SCHMIDT PARCEL
COUNTY OF EL PASO, STATE OF COLORADO
EARLY GRADING AND EROSION CONTROL PLANS

Add text:
PCD Filing No.: CDR227

COVER SHEET

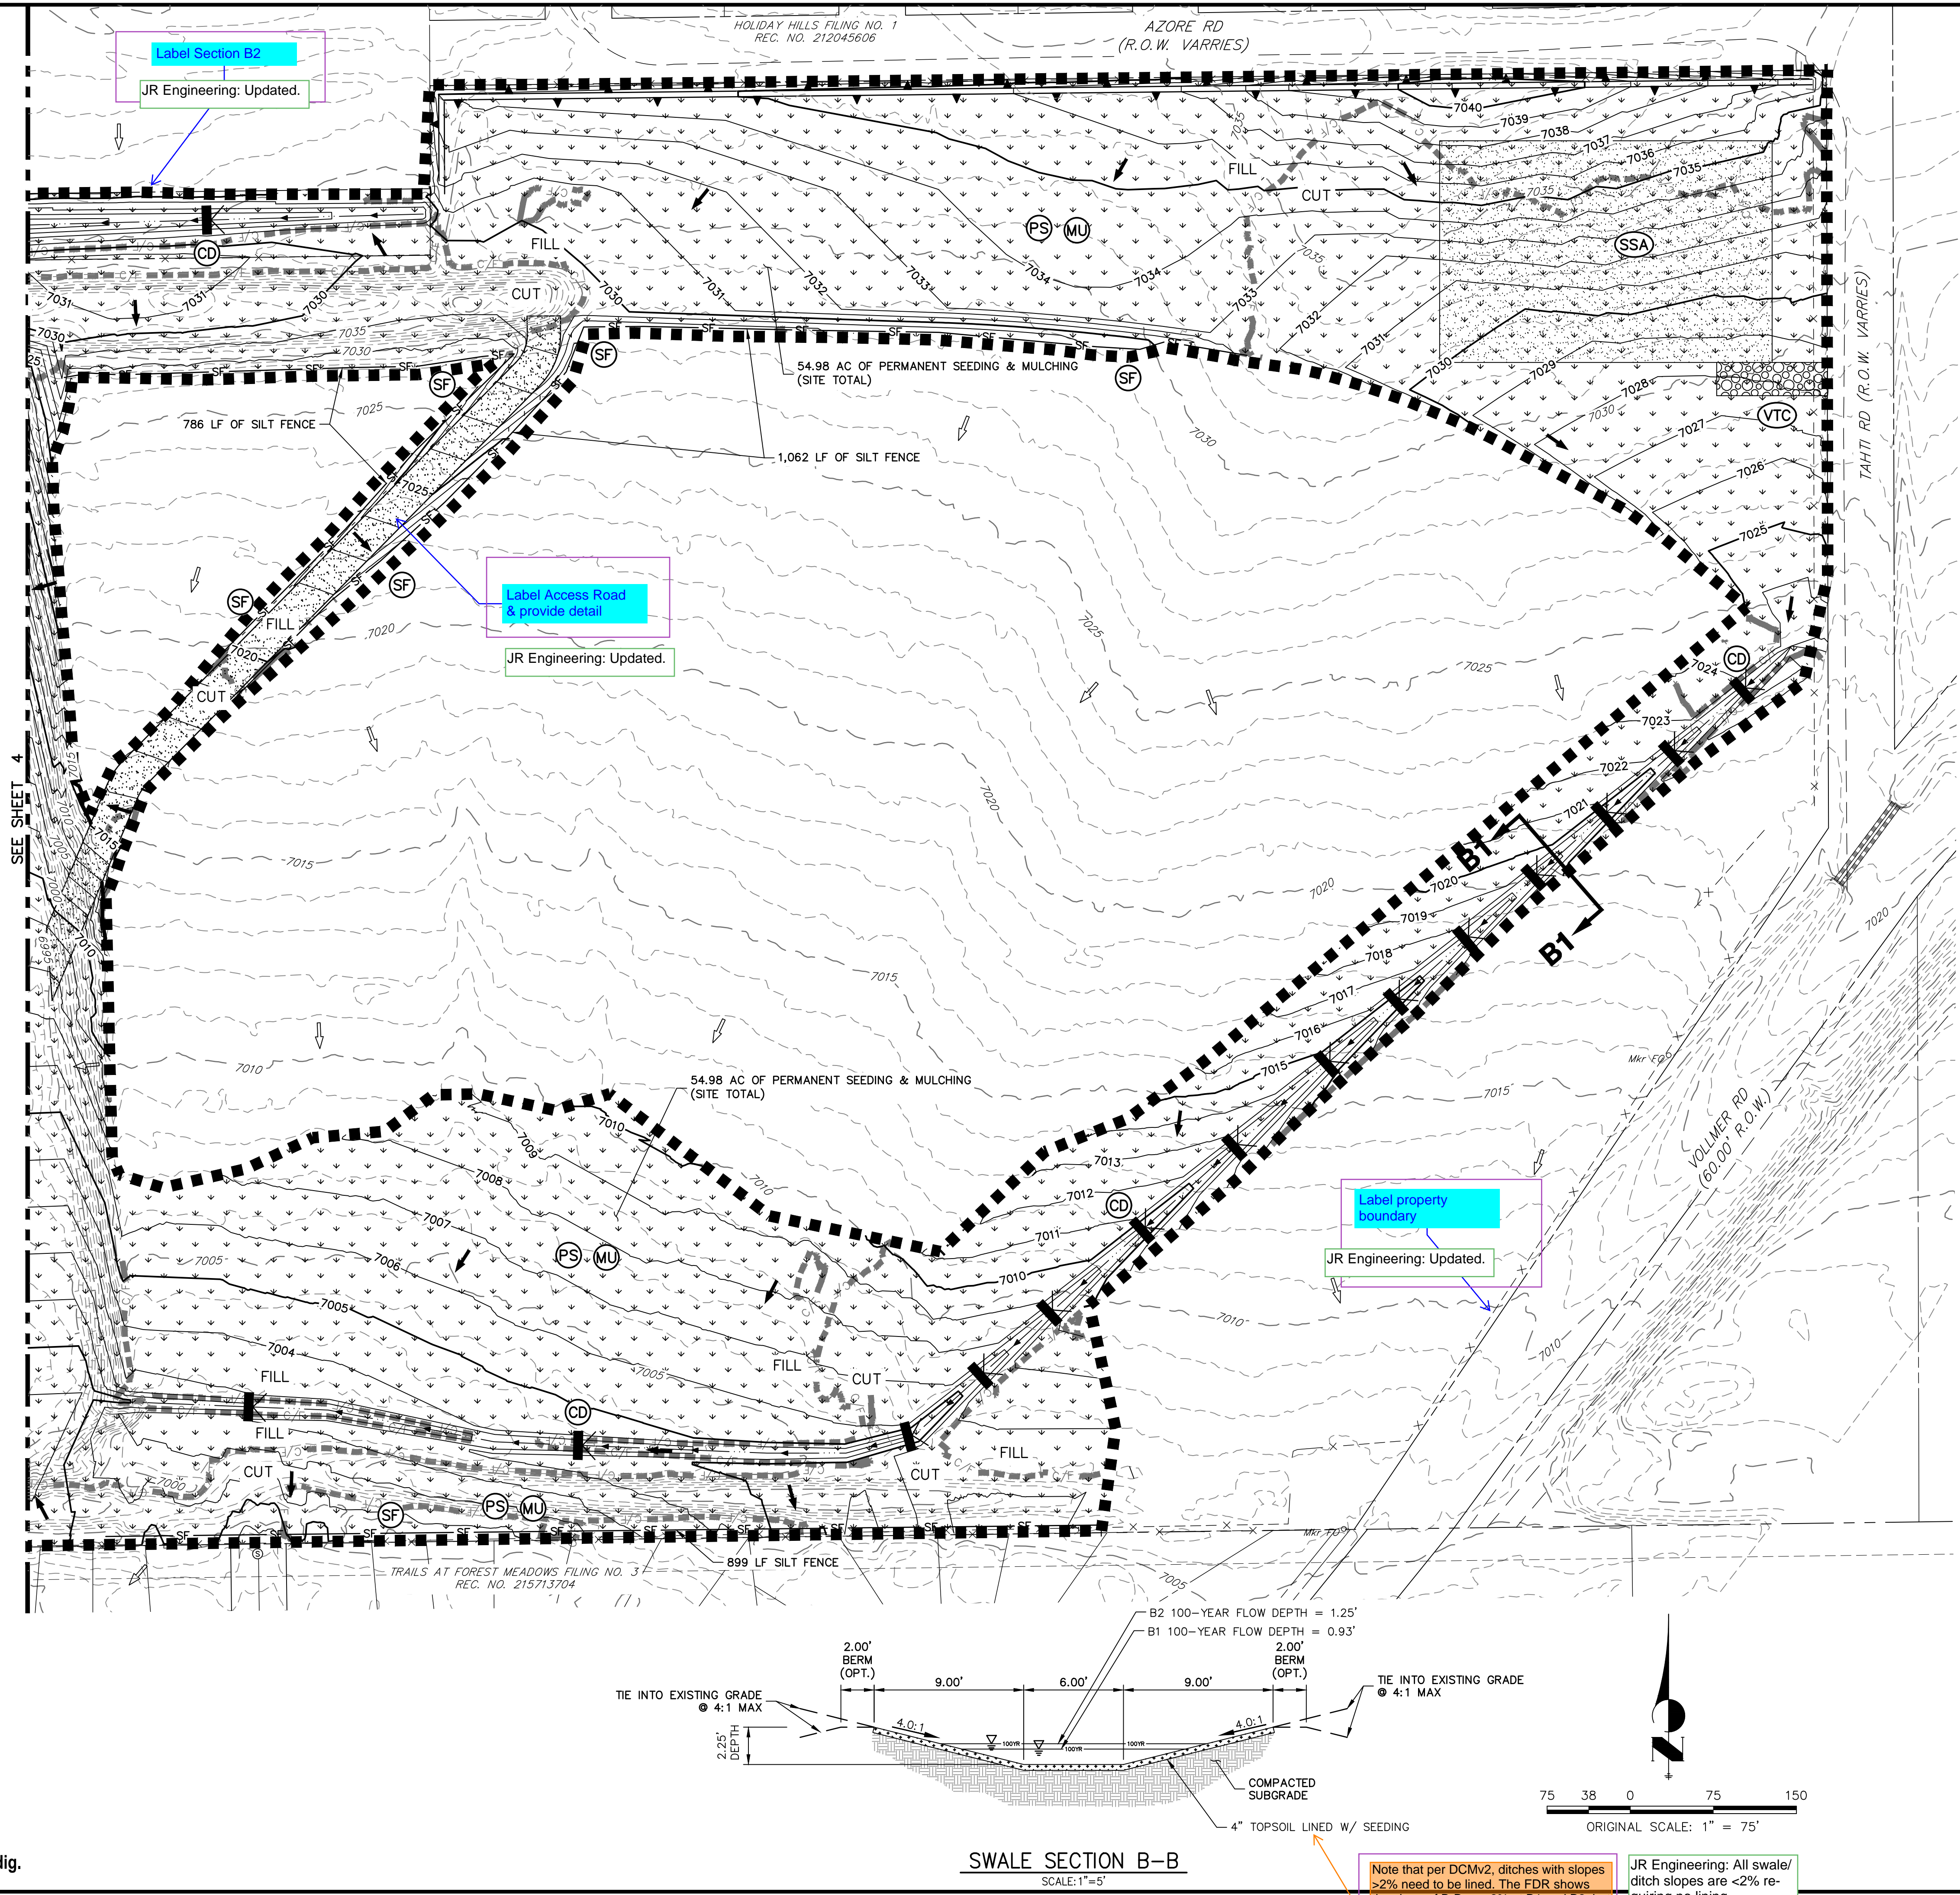
Note: Marksheffel will need to be paved prior to any truck usage/haul routes being utilized to site. Verify if City has any additional concerns or requirements for this.

Label Access Road & provide detail

See comment on pdf pg 10 of the FDR regarding temp sediment basin vs an EDB.

Provide referenced SWMP that includes this design for our review. But also show location of outlet on these GEC Plans.

SWALE SECTION B-B

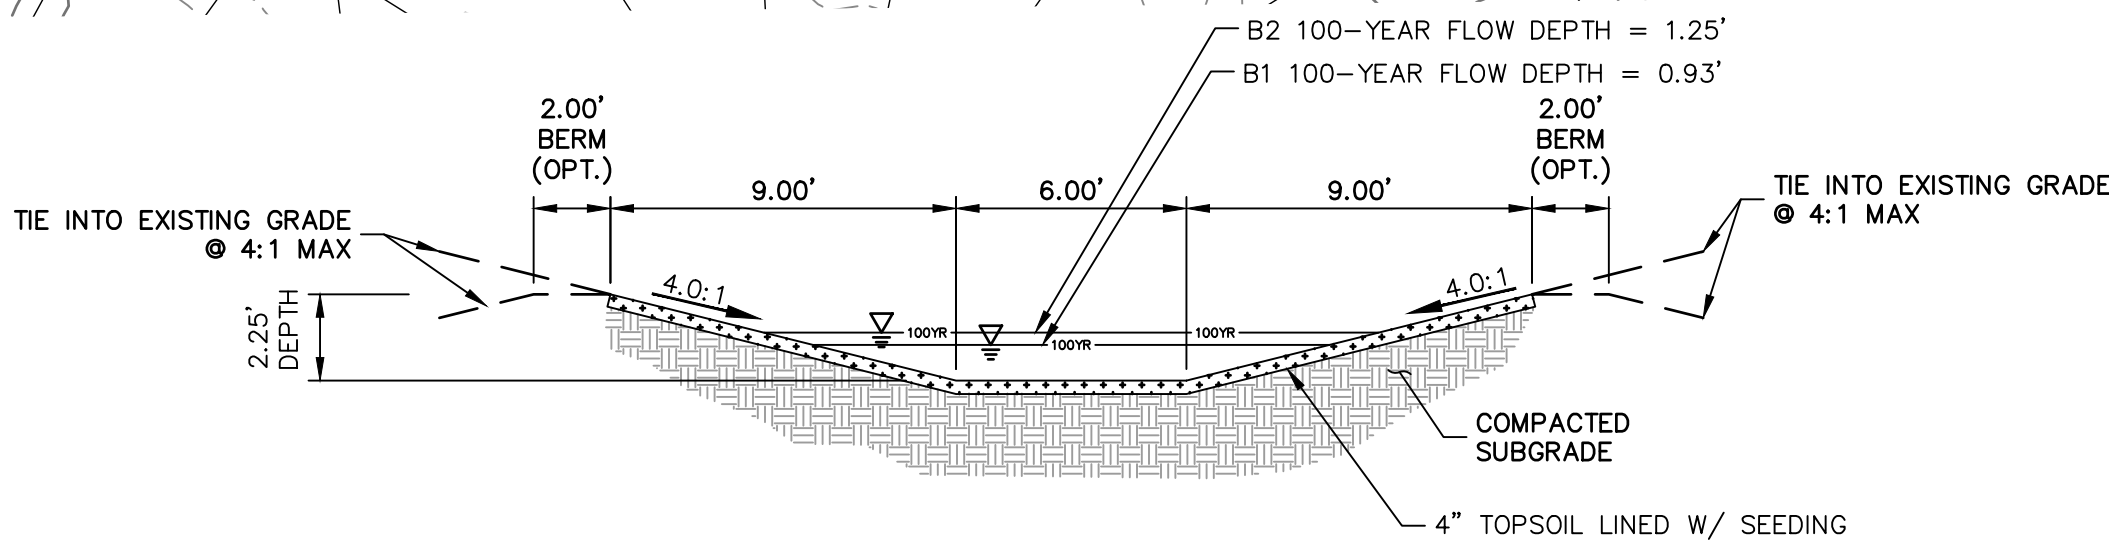
Note that per DCMv2, ditches with slopes >2% need to be lined. The FDR shows the slope of B-B as <2% at B1 and B2, but this is just a general not in case other areas of this or other swales exceed 2%.

JR Engineering: All swale/ditch slopes are <2% requiring no lining.
